District of Tofino  
Tofino Ball Field Improvements

### Addendum # 1

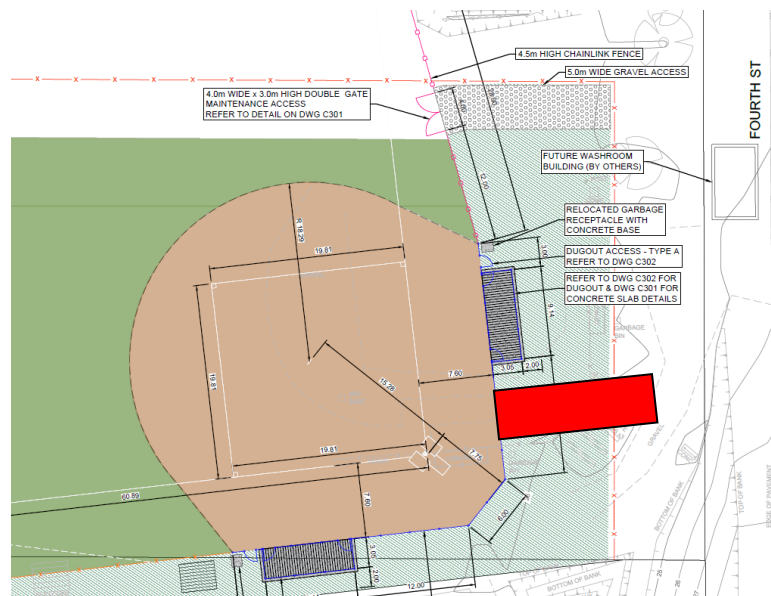
4. Question: Based on site visit the proposed gravel access appears to be in conflict with new parking lot. Is this gravel access location going to be revised prior to construction?

**Answer: Yes, the daycare parking layout has changed which will require an adjustment to gravel access location. It is anticipated that the access location and maintenance gate will be relocated as shown below in red.**
